Access Compliance Report

Public Rights-of-Way

Intersection ID: 25402		Main Street: HONEY_CREEK_LN		Cross Street: WEDDINGTON_RD		Location: SE			
ADA ID: 1EC38580AF8C		Ramp Type: PerpDiag		Initial Pass/Fail: Pass		Overall Compliance: No		Severity Score: 10	
Codes/Mitigation Info/Possible Solution					Field Measurements/Component Compliance

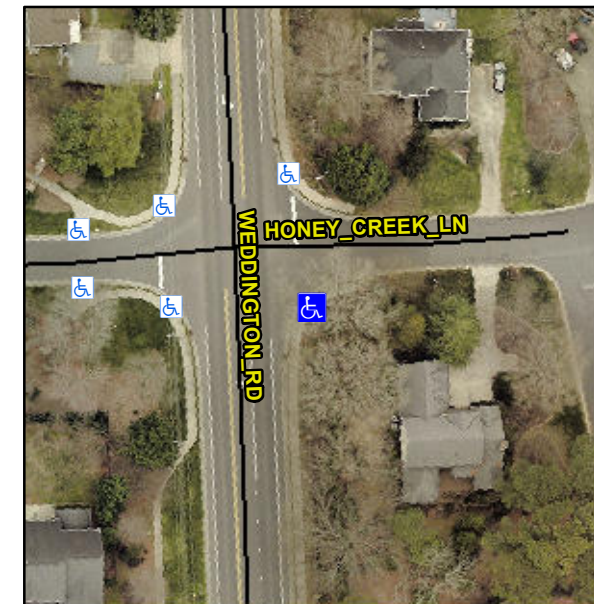
Remove & Replace Curb Ramp With Two New Directional Ramps or Equivalent.

Not Found, R304.2.1, R304.2.2-Perp, R304.3.2-Para, R304.5.3
